Subject: Change notification for ClipTip 1250 µl pipette tips

Thermo Fisher Scientific is pleased to announce that we have made enhancements based on customer feedback to the Thermo Scientific™ ClipTip™ 1250 µl Pipette Tips to improve performance of the tips when used with E1-ClipTip pipettes.

OLD CT1250 NEW CT1250

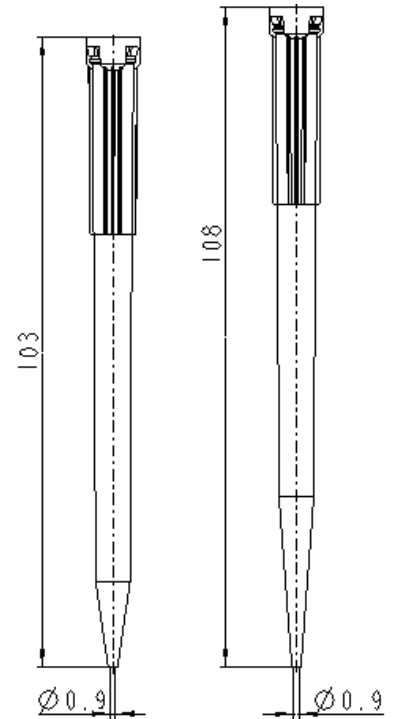
- Thinner and pointier shape that allows more precise aspiration from the bottom of vessels
- 5 mm longer tip, enabling better reach
- New filter raw material and a shorter filter that improves stepping performance
